City of Portland, Maine - Building or Use Permit Application

BUILDING PERMIT REPORT

REASON FOR PERMIT: Replace balconies & handrails

Project:
 HOWARD JOHNSON
 PORTLAND, MAINE

Project: **HOWARD JOHNSON
 PORTLAND, MAINE**
 Sheet Contents: **BALCONY PLAN VIEWS & ELEVATIONS**

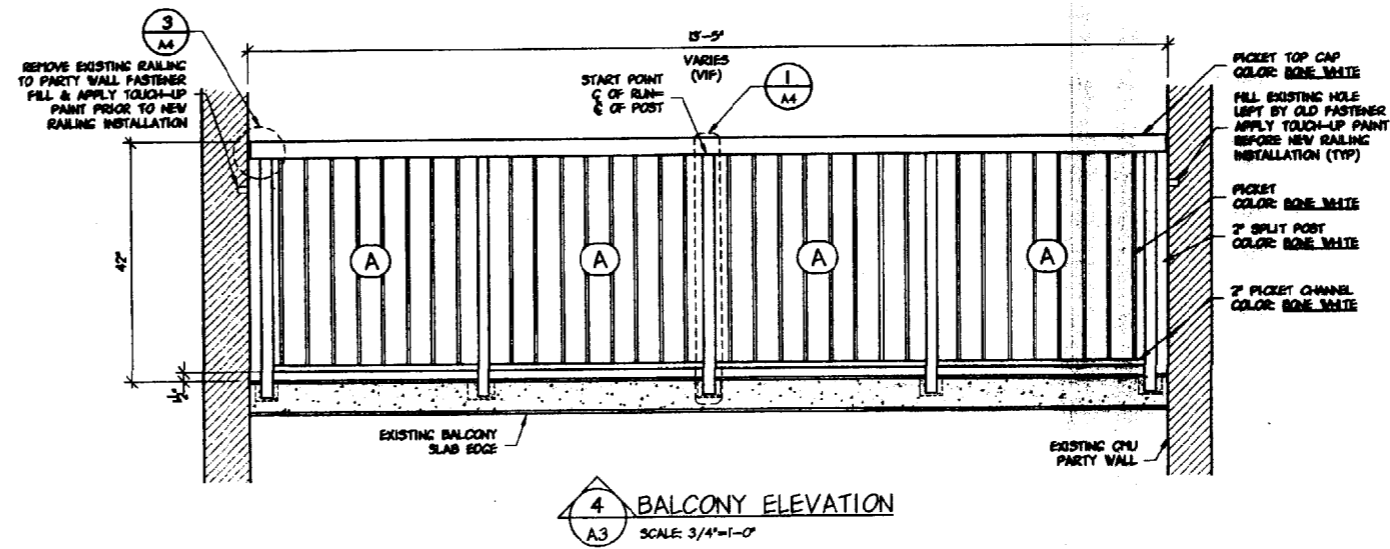
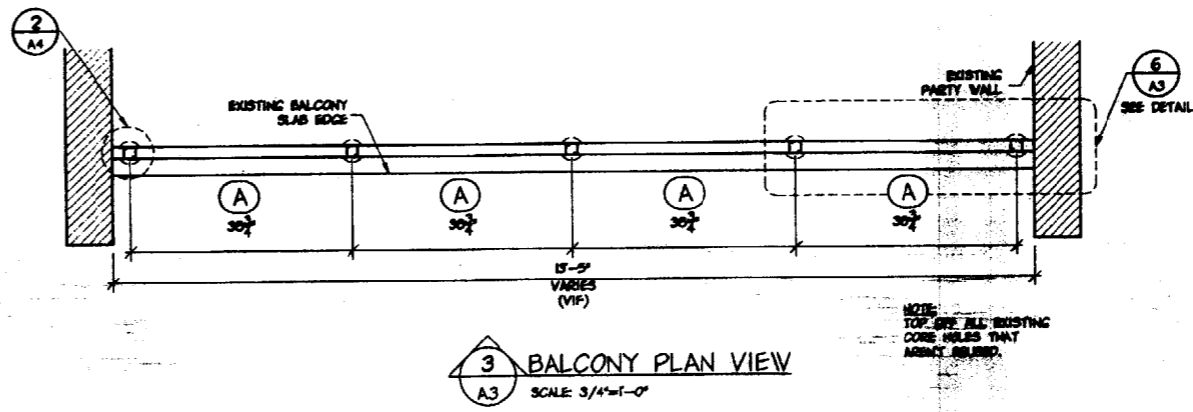
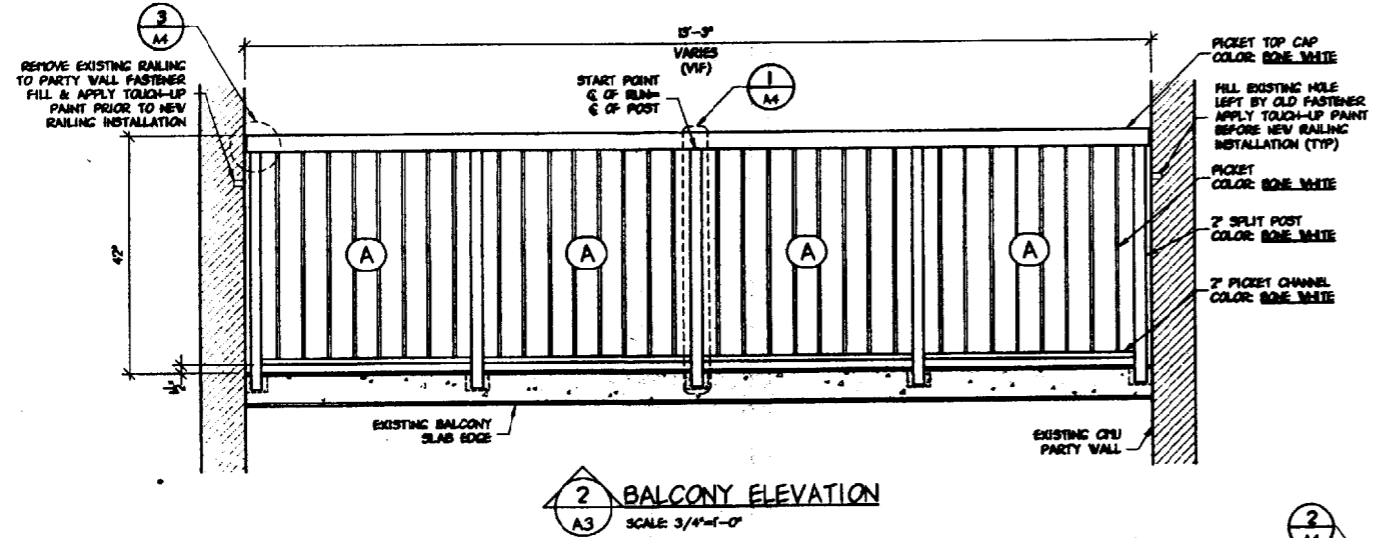
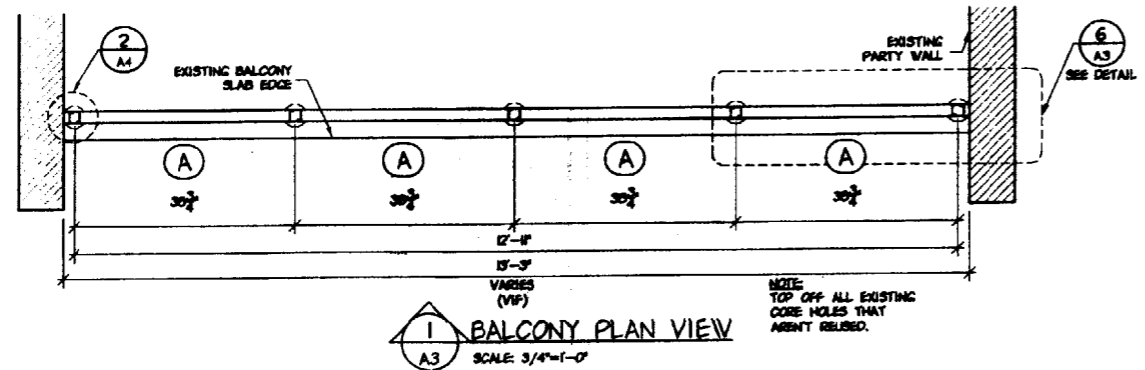
*Guandra's
 sec. 1921.6
 Loads on Guandra
 sec. 1686.4*
